Date: November 30, 2023
To: All Vendors
Subject: Addendum #2

**REFERENCE: B014-24 Re-Bid BPUB Downtown Wastewater Improvements-ARPA
Project 1**

Project:	Brownsville PUB – Downtown Wastewater Improvements ARPA Project 1 BPUB Bid No. B014-24	Addendum Date:	November 30, 2023
From:	Javier A. Esquivel, PE	Project No.:	BPUB2200025.01

ADDENDUM No. 2

SHEET
CA06

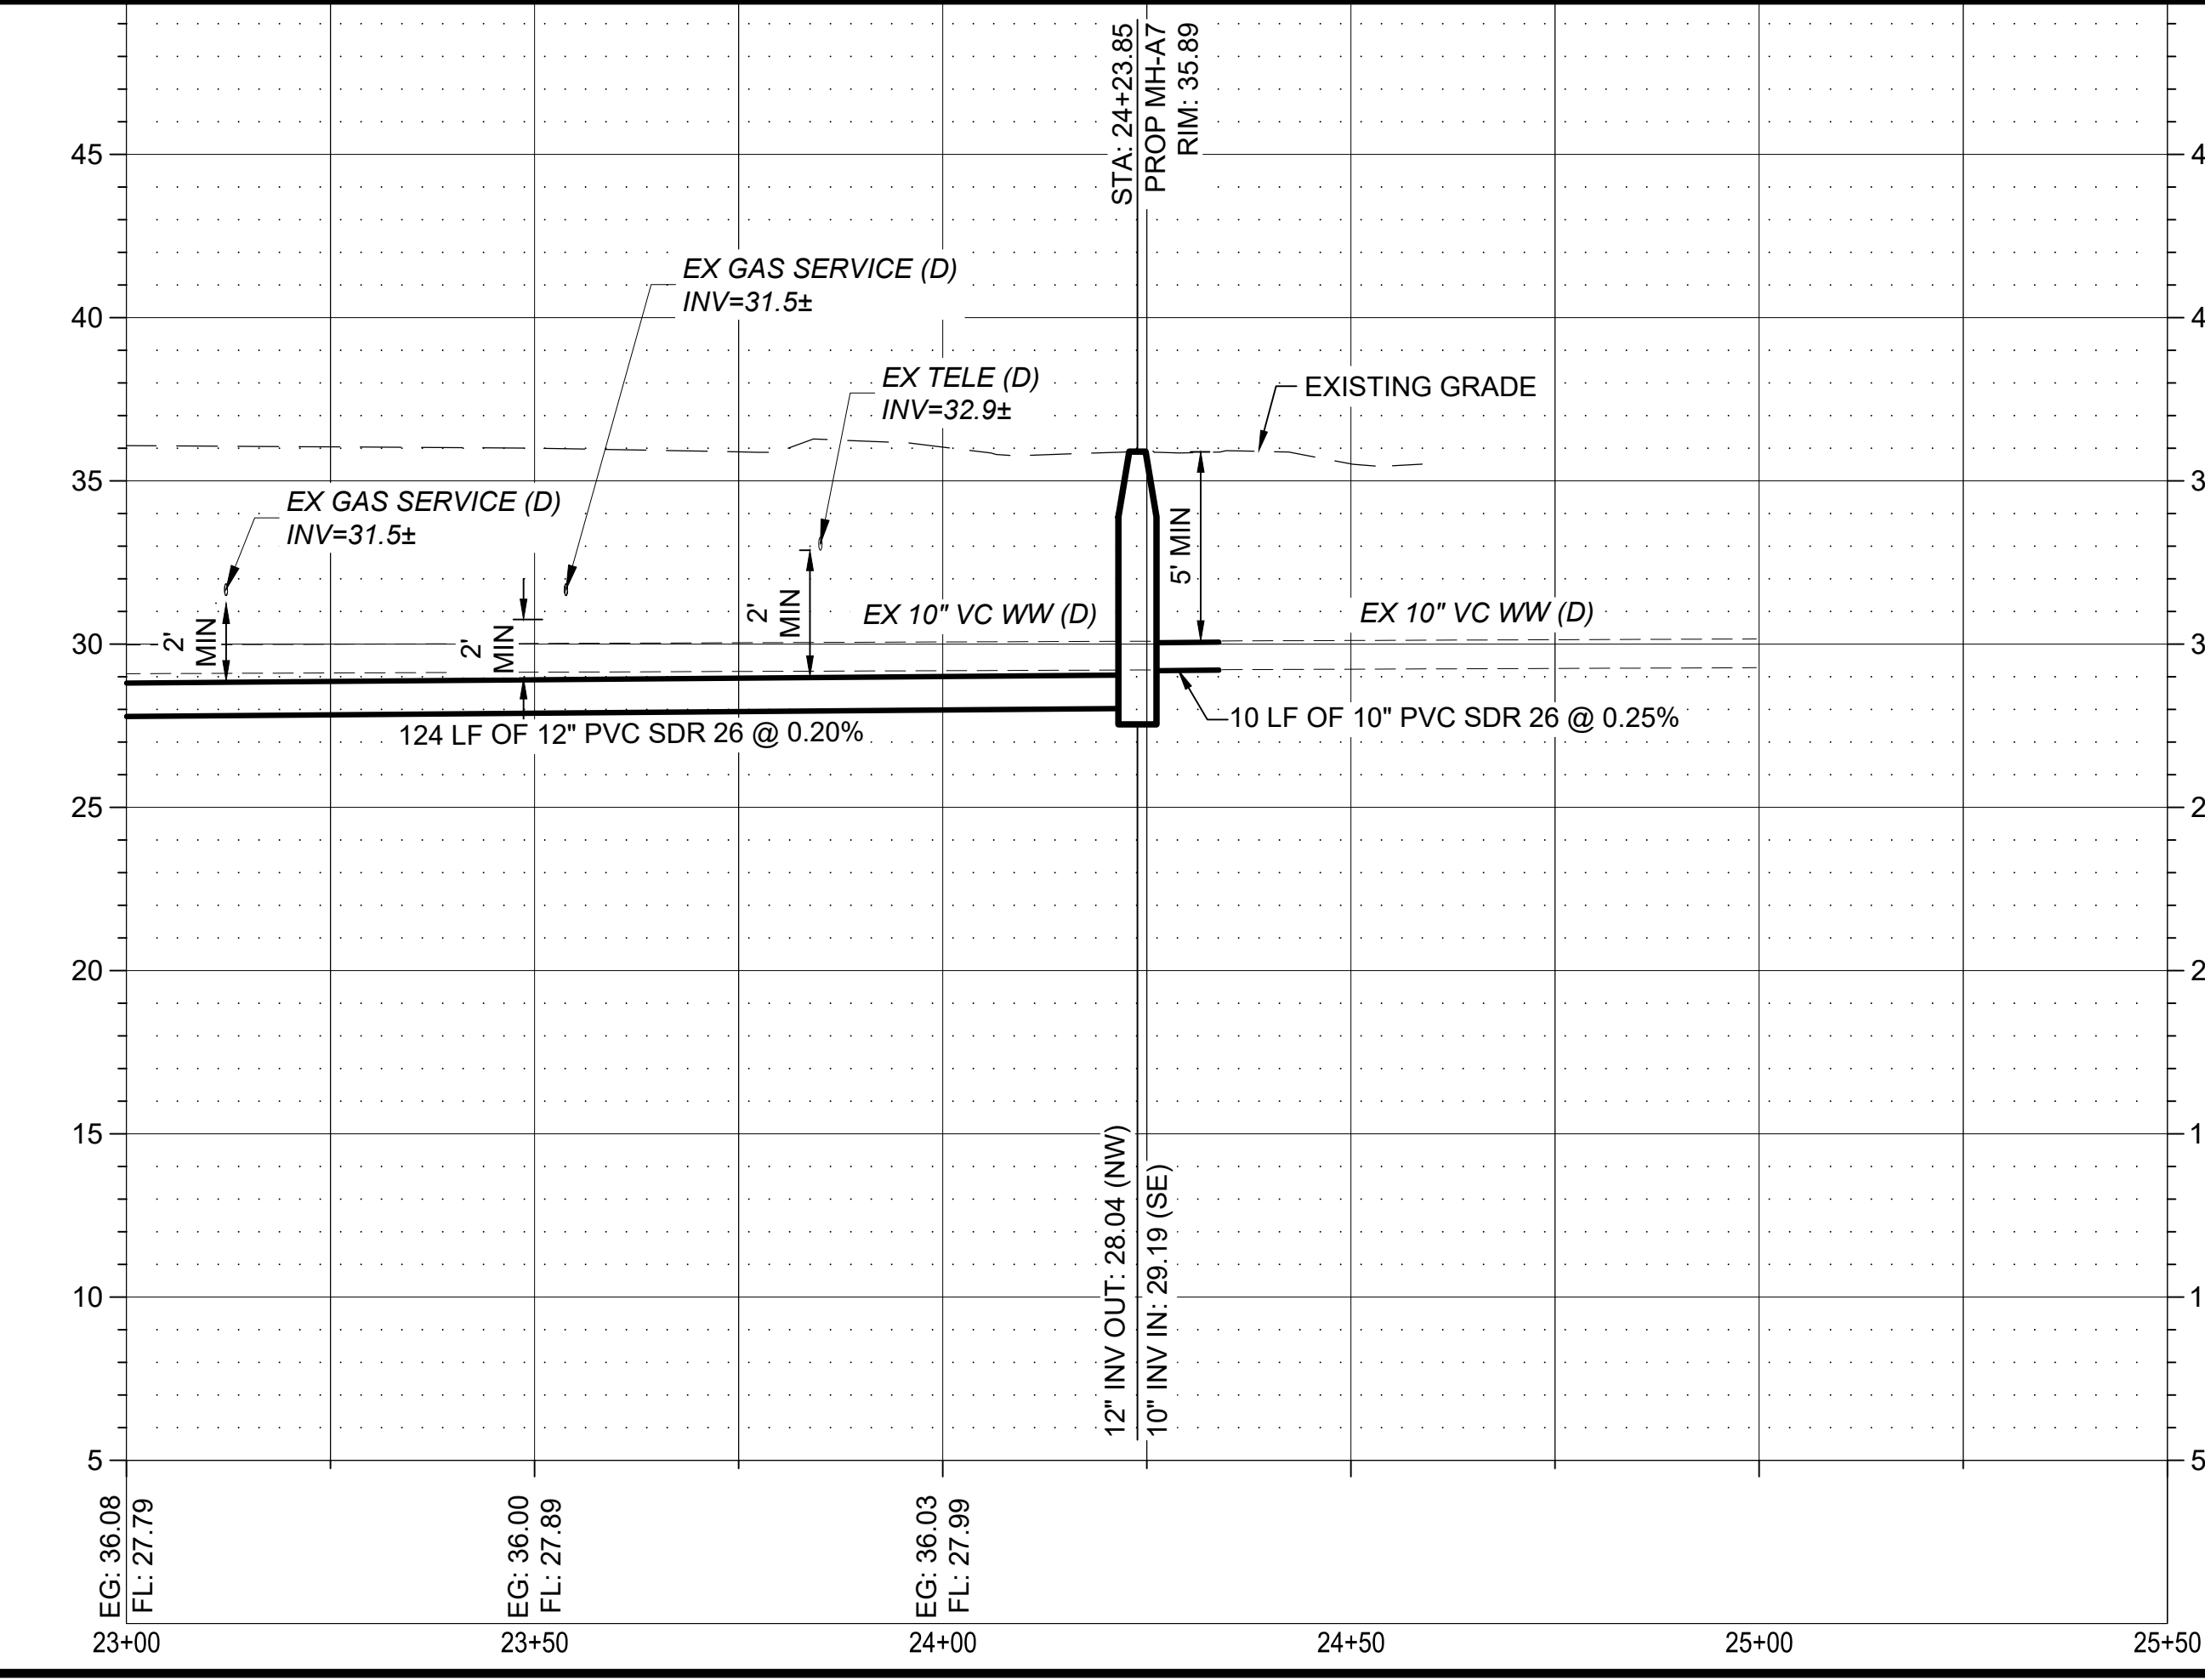
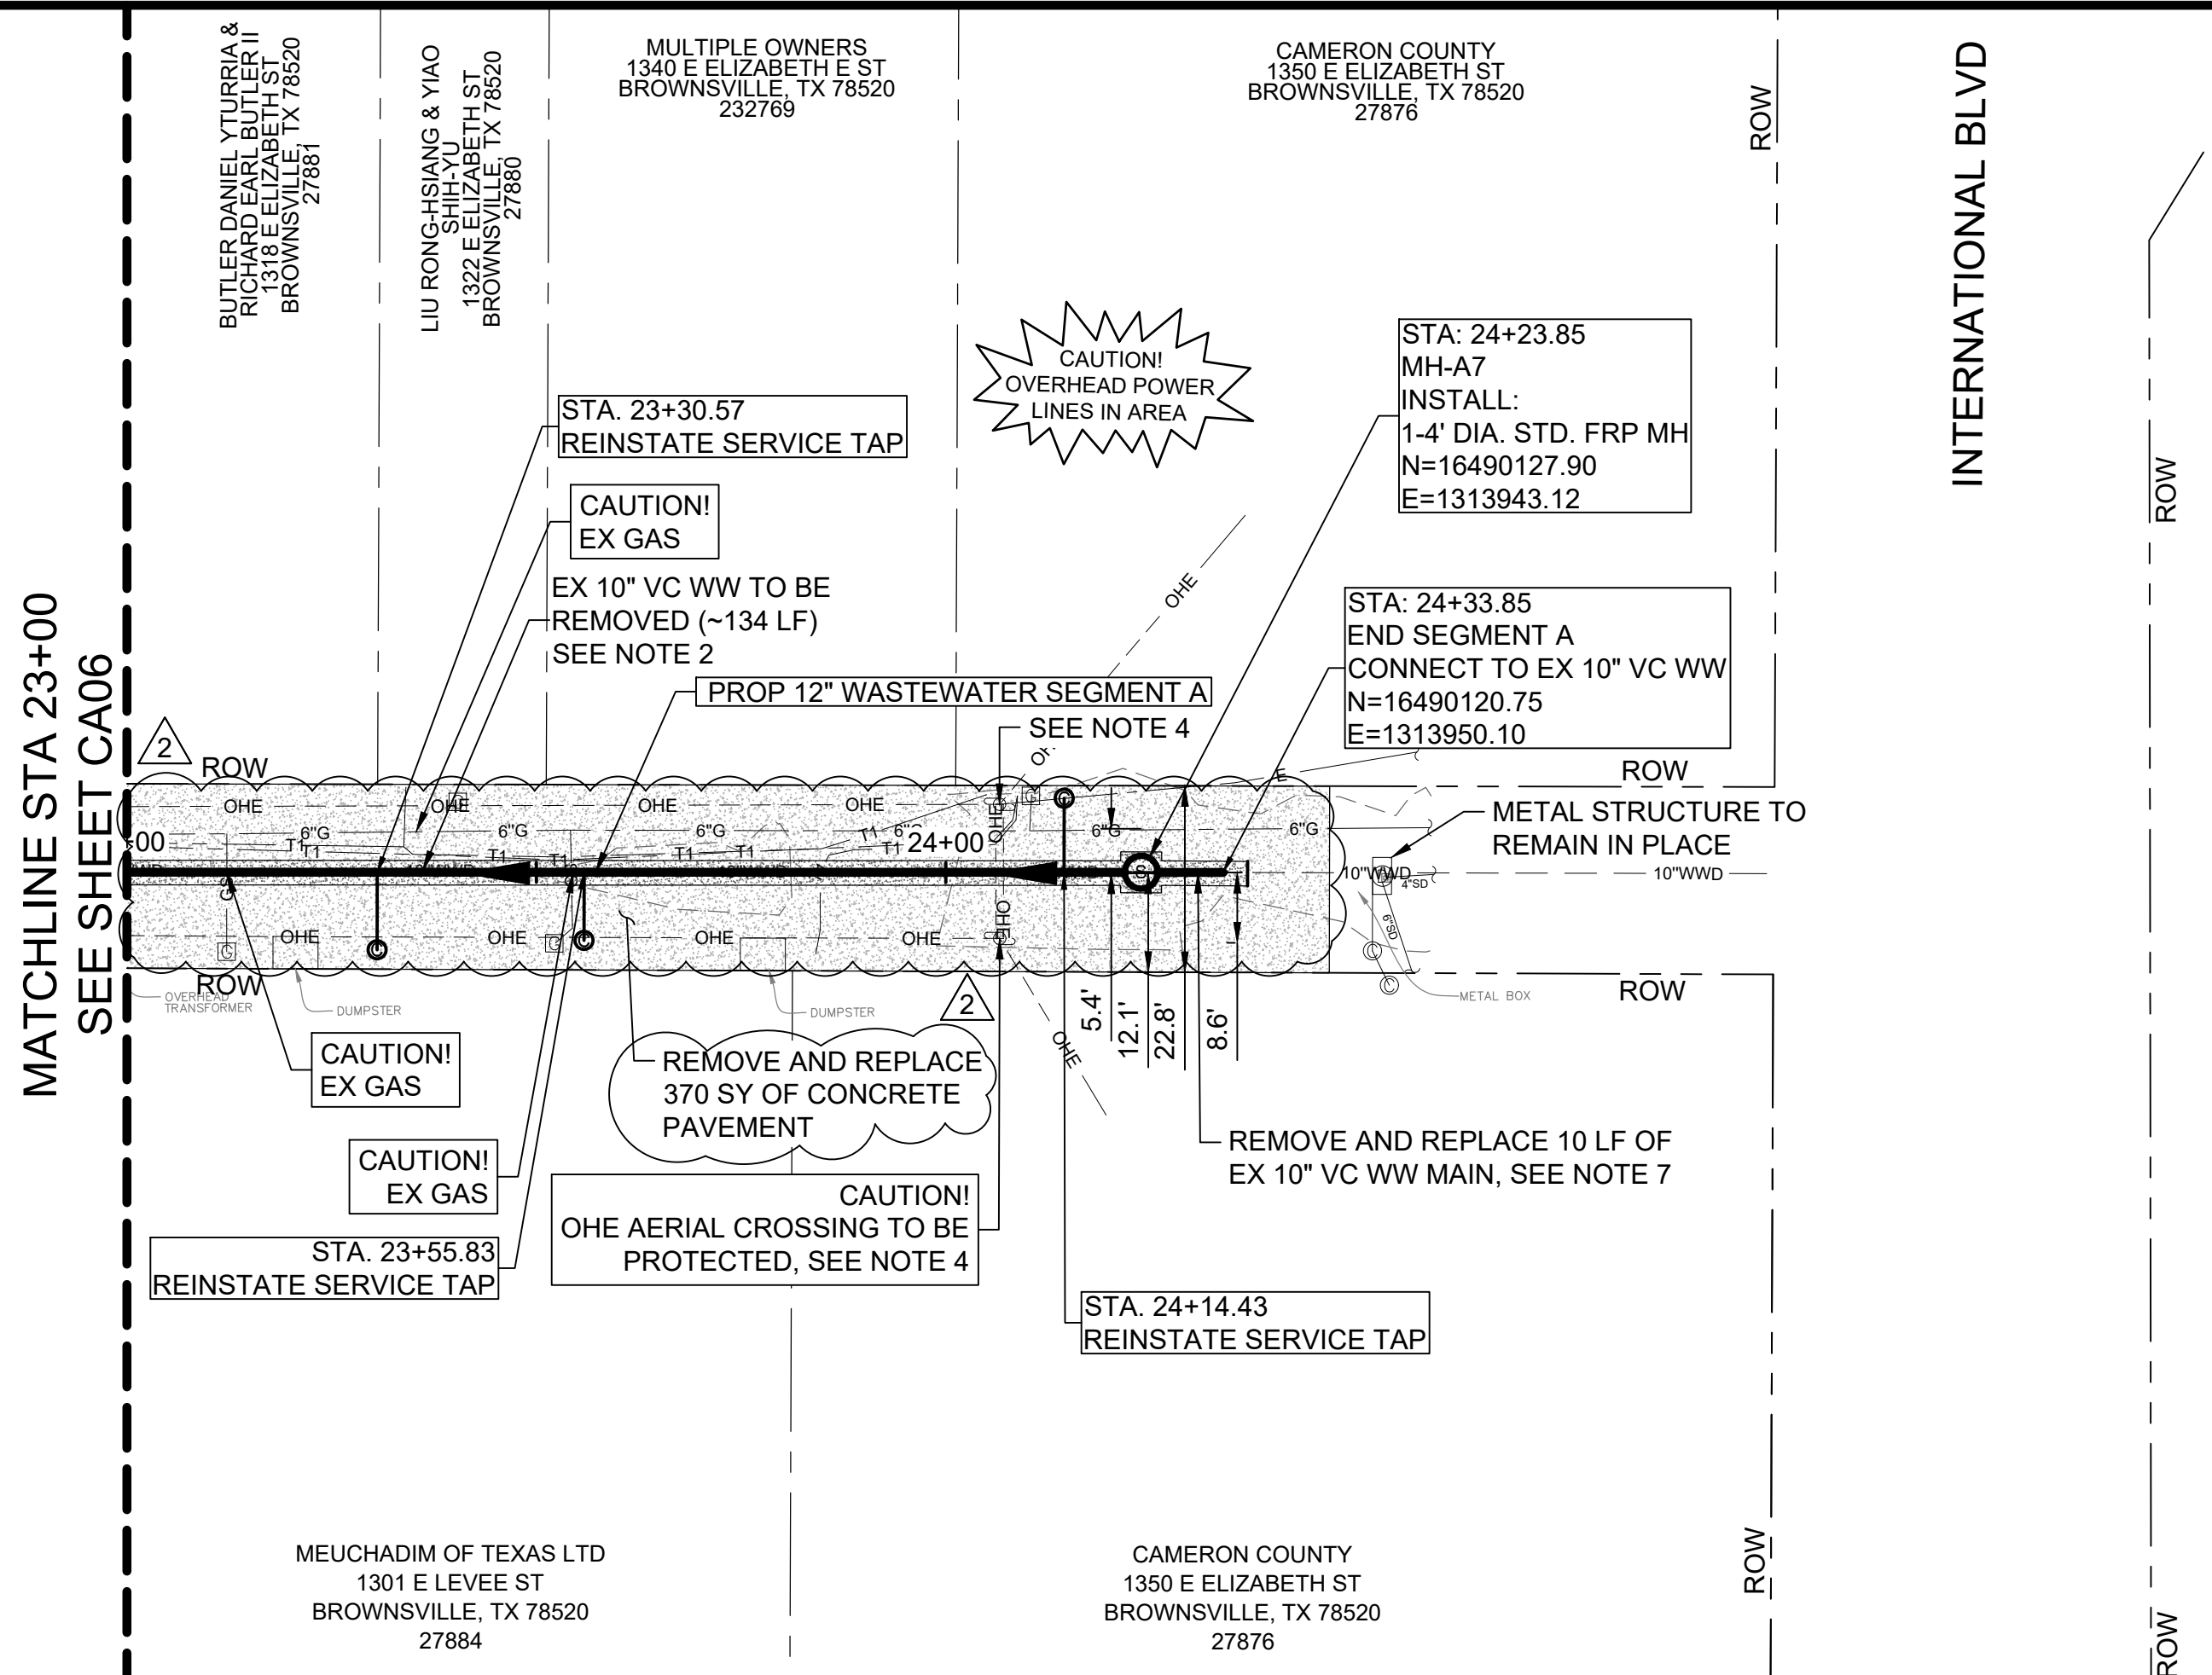
1. Revisions to Surface Restoration in the Alleys.
 - Segment A: Replace Mill and Overlay (2”) with full depth concrete asphalt pavement removal and replacement.
 - Segment B: Replace Mill and Overlay (2”) with full depth asphalt pavement removal and replacement.
 - Segment C: Replace Mill and Overlay (2”) with full depth asphalt pavement removal and replacement.

3. Plan Sheets: The following plan sheets were modified to update surface restorations CA02, CA03, CA04, CA05, CA06, CA07, CB01, CB02, CB03, CC02, CC03, CC04, and CC05.
